Appeal Decision

Appeal Ref: APP/HS2/22

Site extending from the northwest of Leather Lane to the west of Jone's Hill Wood between the settlements of South Heath and Wendover Dean, Buckinghamshire

The location of Fusion parcel reference numbers C21052P and C21054P are identified within the High Speed Two ArcGIS Web Map dated 27 June 2022 below.

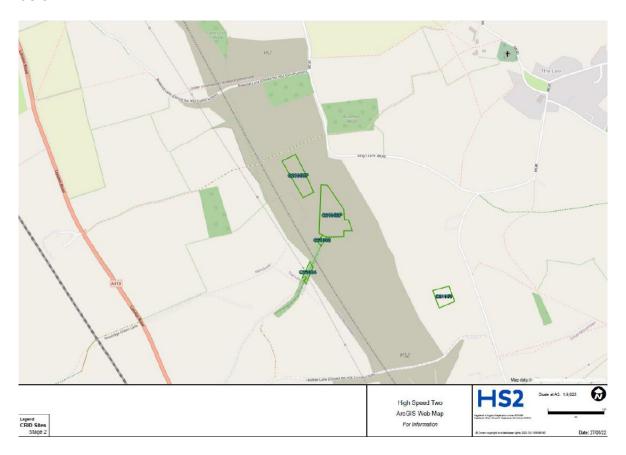
1) No development or preliminary groundworks of any kind shall take place within Fusion parcel reference numbers C21052P and C21054P until a Method Statement for preservation of archaeological remains has been submitted in writing and approved by the planning authority.

- 90. To ensure the specifications stated in the Form A(s) are implemented when the approved earthworks are being undertaken, I consider those documents should be added to the list of approved documents cited on the decision notice issued by the Council on 22 July 2022. That would bring the implementation of the specifications to preserve buried archaeology within parcels C21052P and C21054P within the scope of paragraph 3(1) of Sch17²³, namely that works approved under Sch17 must carried out in accordance with approved specifications. Accordingly, in my formal decision above, I have made provision for the list of the approved plans to be amended so that the Form A(s) are added to it.
